# HISTORIC AND DESIGN REVIEW COMMISSION

**HDRC CASE NO:** 2020-252  
**ADDRESS:** 328 E JOSEPHINE  
**LEGAL DESCRIPTION:** NCB 975 (BOEHLER'S SUBD), BLOCK 18 LOT 15  
**ZONING:** C-3, RIO-2  
**CITY COUNCIL DIST.:** 1  
**APPLICANT:** Kristen Weber/Don B. McDonald, Architect  
**OWNER:** RIO PERLA PROPERTIES LP  
**TYPE OF WORK:** Amendments to a previously approved design, new construction, site work  
**APPLICATION RECEIVED:** June 12, 2020  
**60-DAY REVIEW:** Not applicable due to City Council Emergency Orders  
**CASE MANAGER:** Edward Hall  
**REQUEST:**

The applicant is requesting a Certificate of Appropriateness for approval to amend a previously approved design. Within this request, the applicant has proposed the following:

# Boehler's Bar Kitchen Wall & Service Area Revision

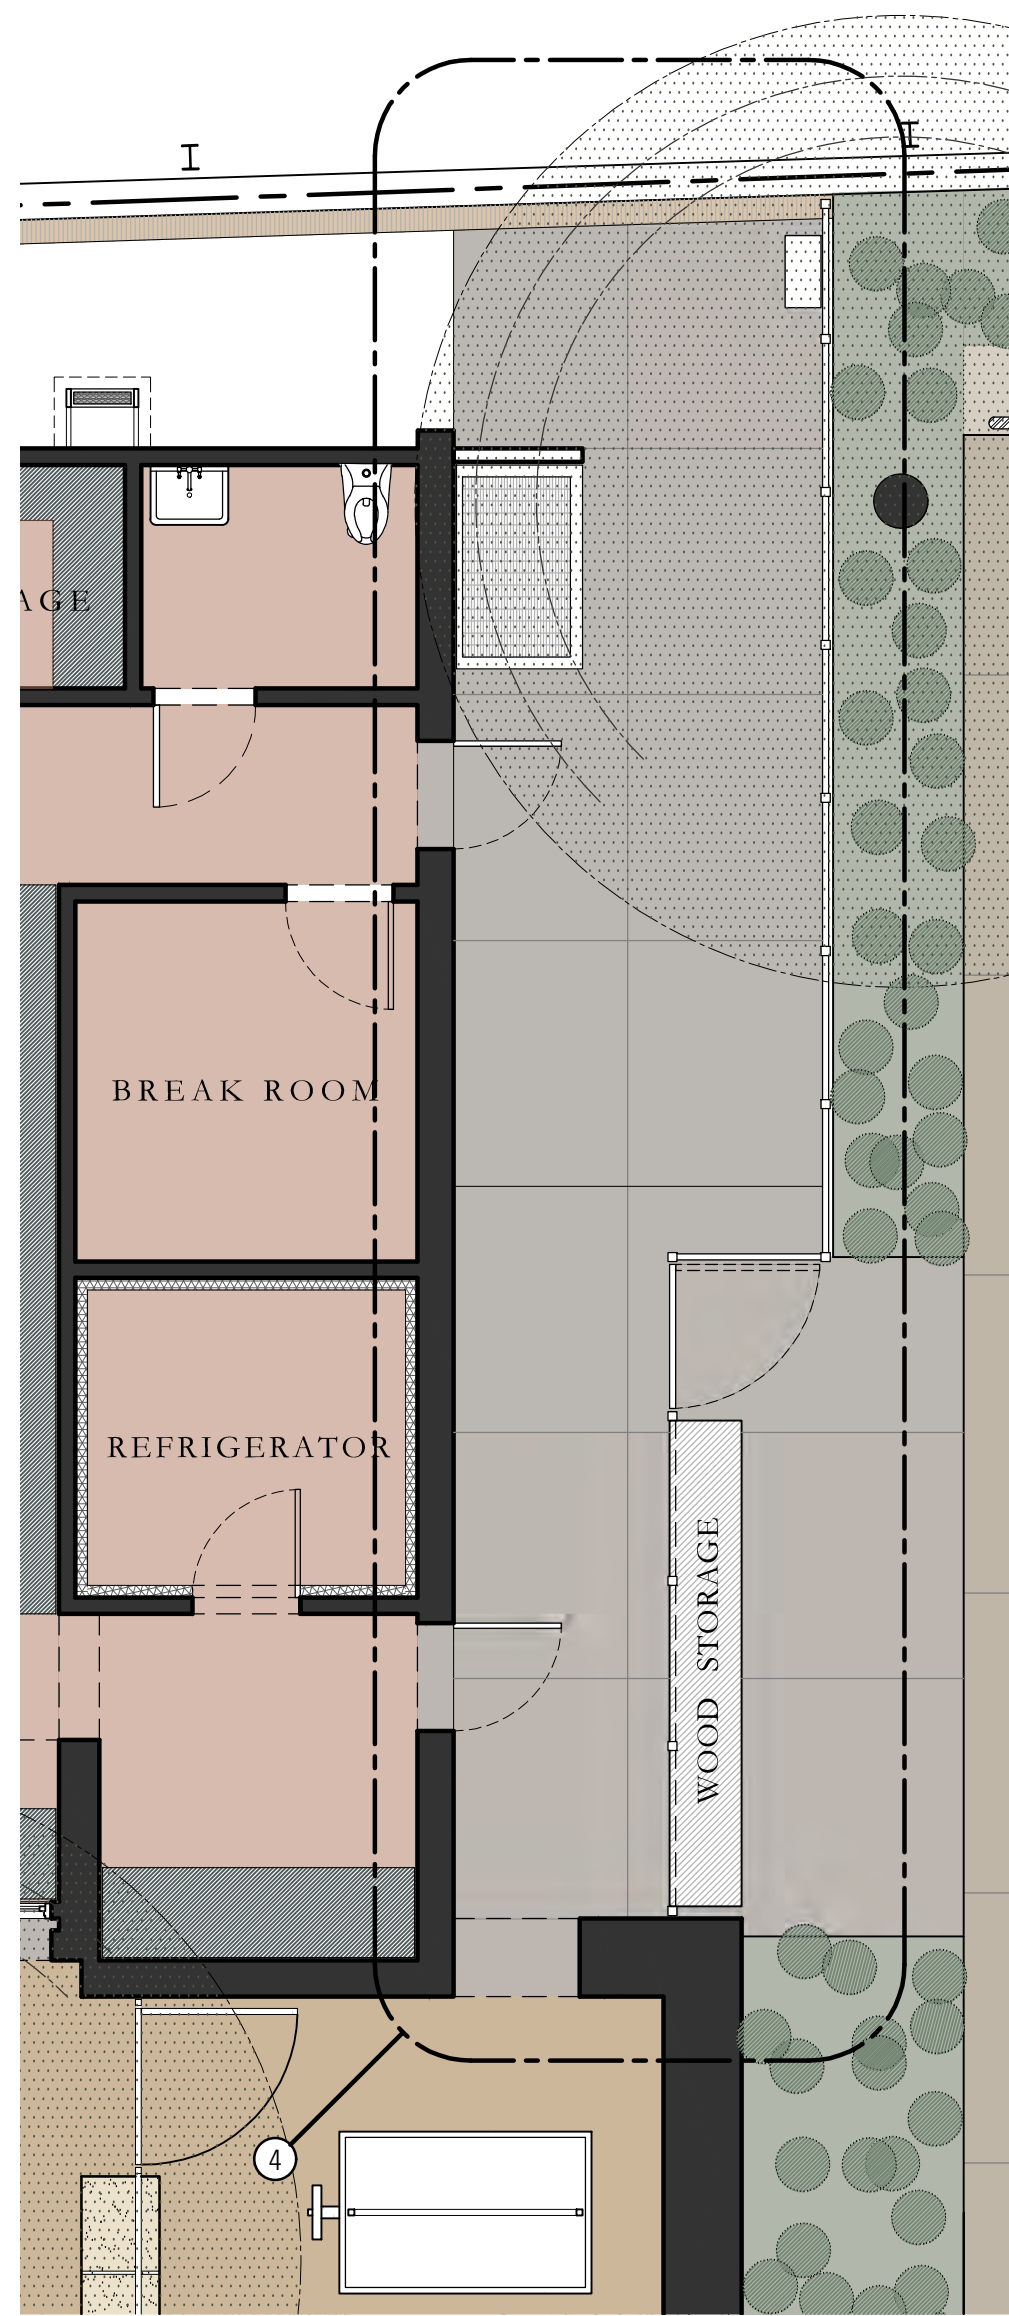
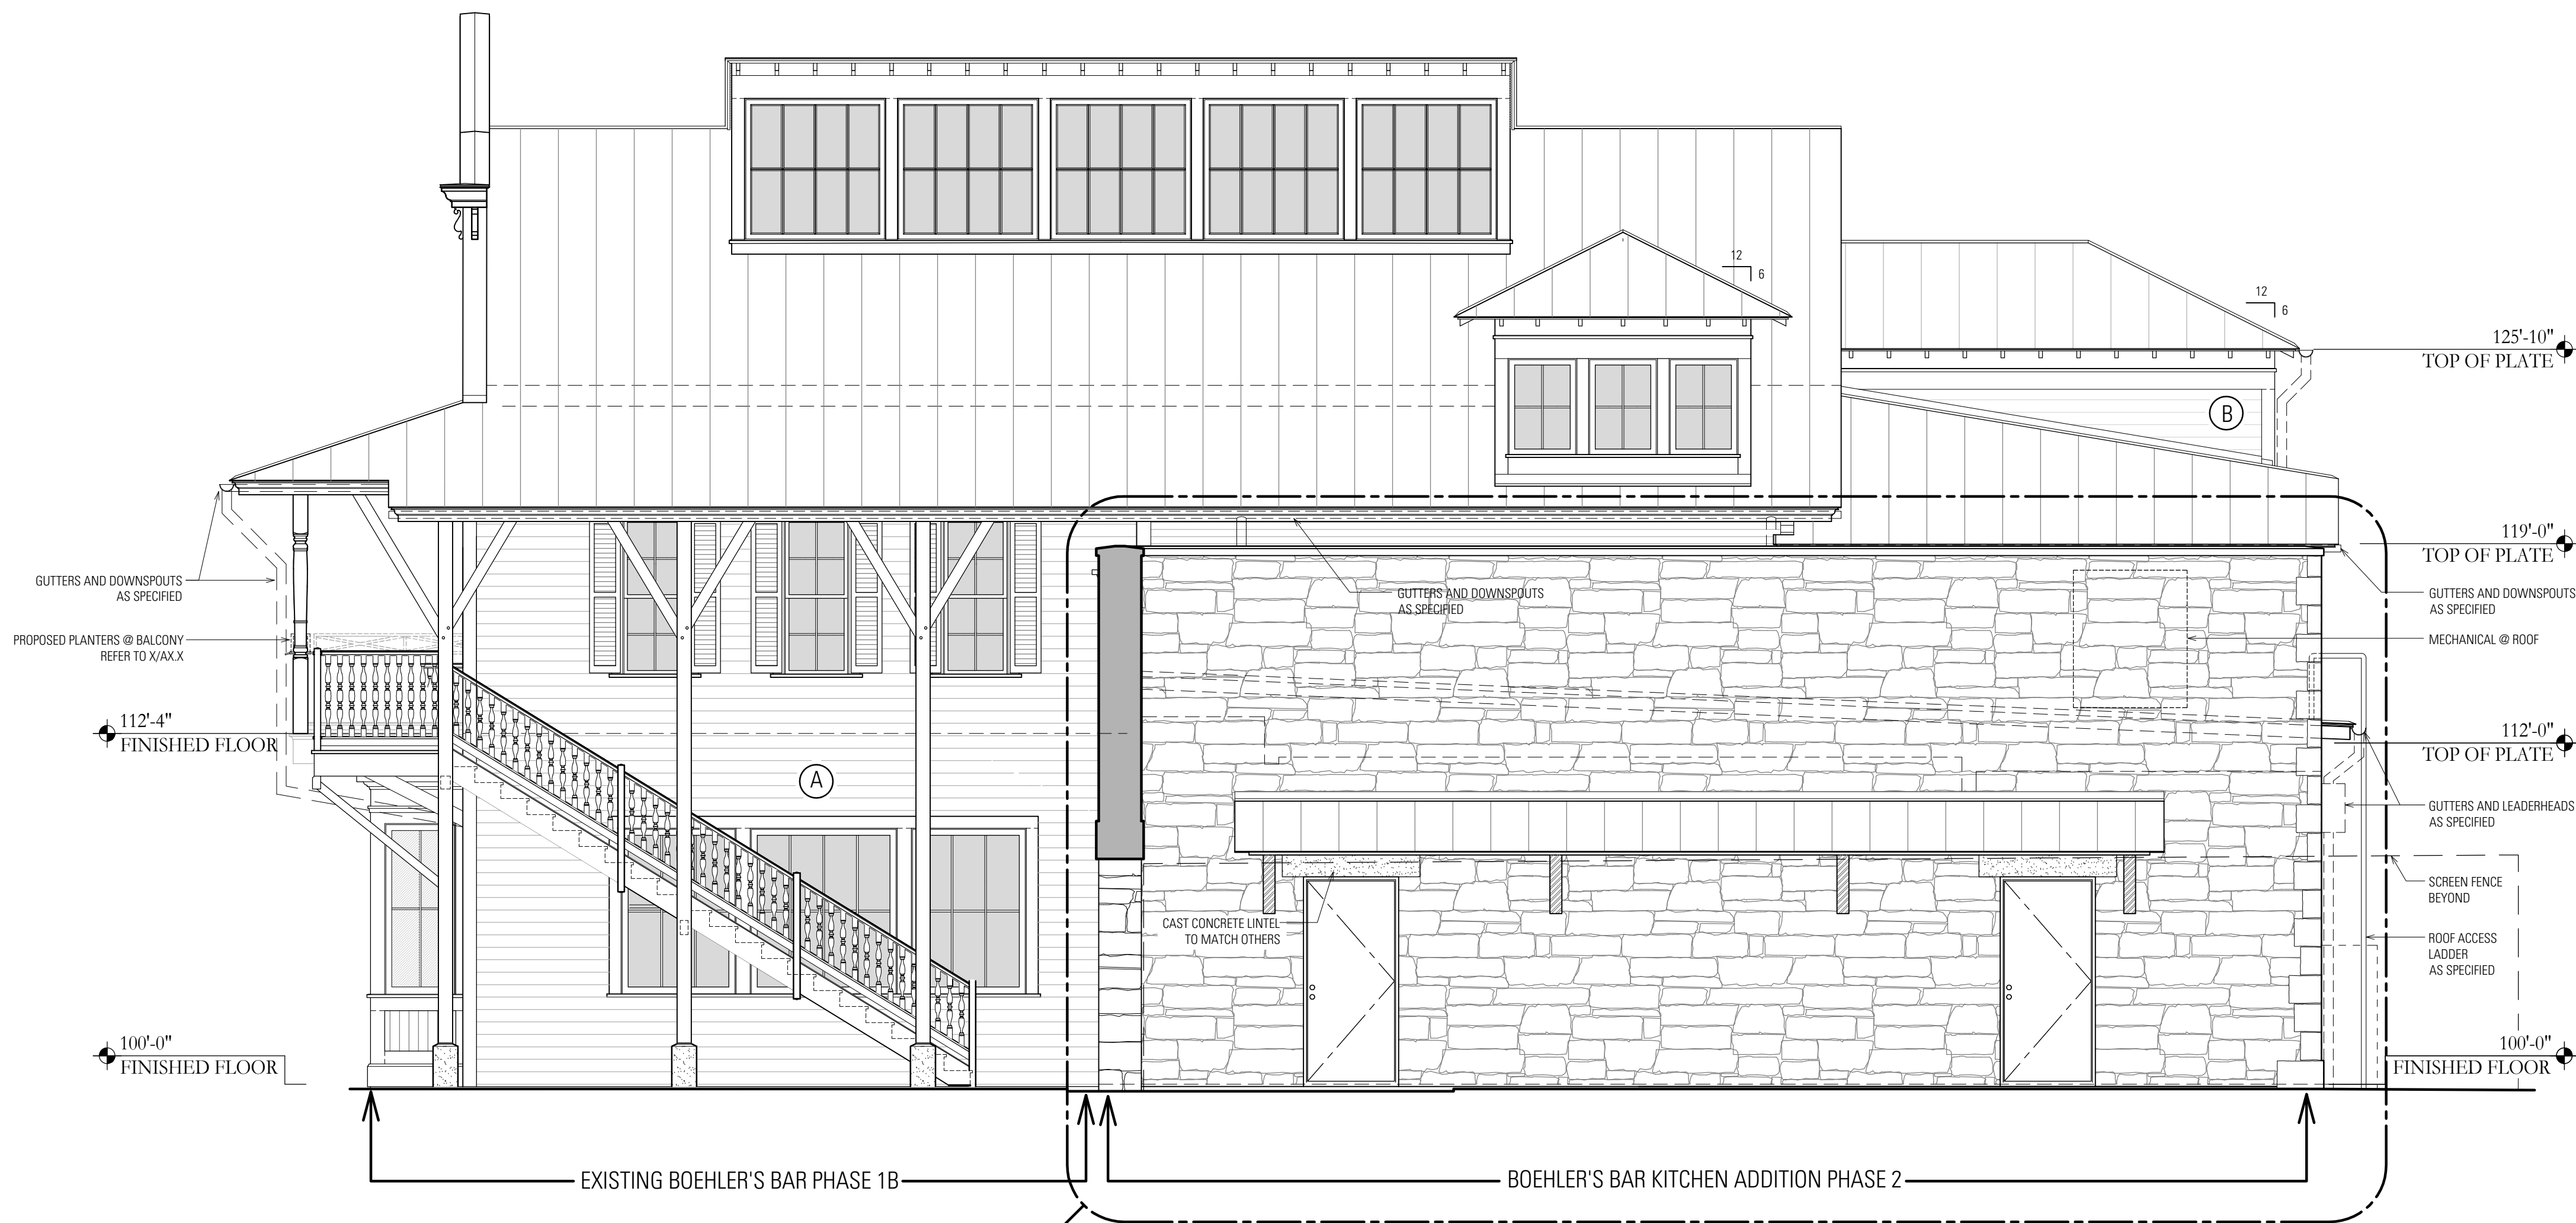
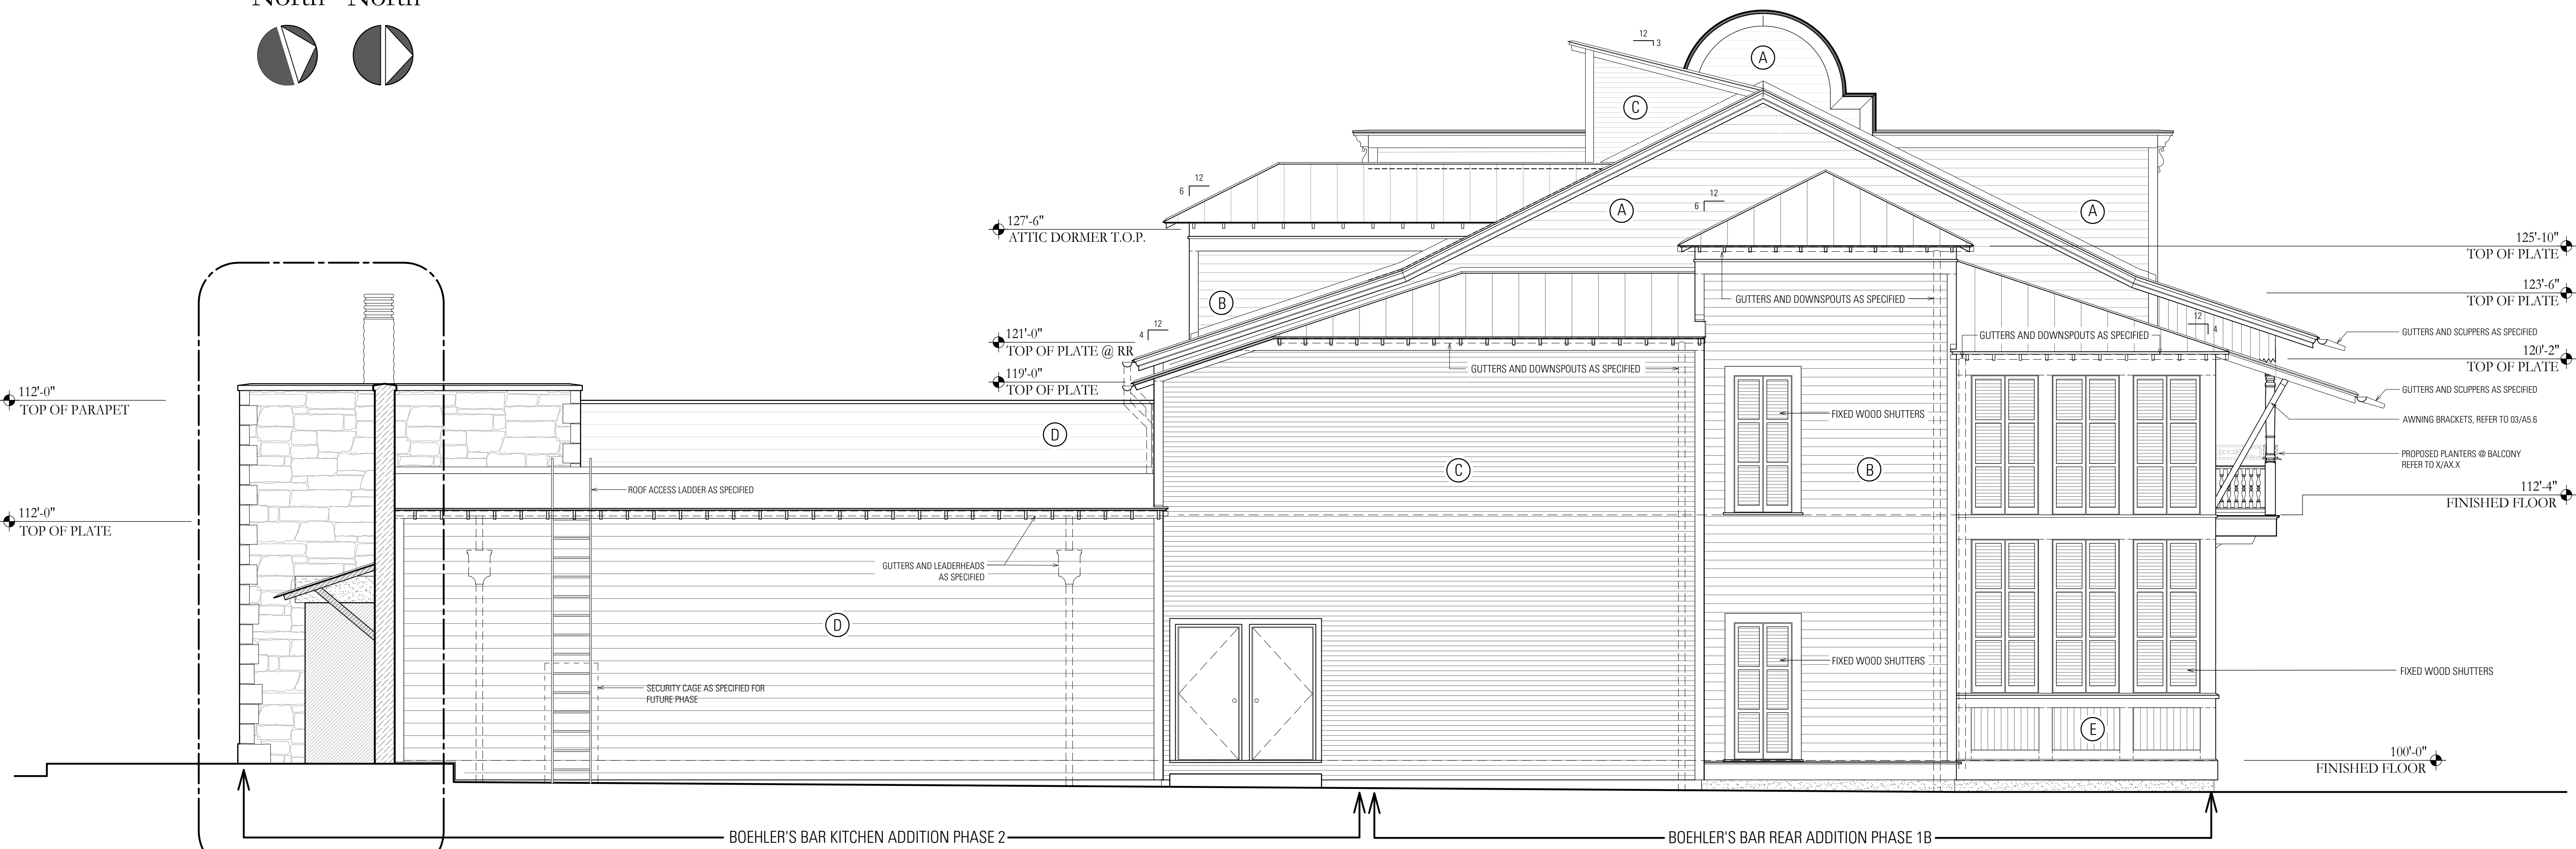
4. Shift the previously proposed north stone wall to the south to act as a parapet wall to the Boehler's Bar kitchen addition.
5. Create two barbeque pits and roofs with exhaust vents in the Boehler's Bar kitchen courtyard.

The North wall that stood independent of the Kitchen has shifted south to engage with and create a parapet to the north side of the Kitchen. A 10' wire mesh vine covered fence will replace it. Benefits are light, air and more green.
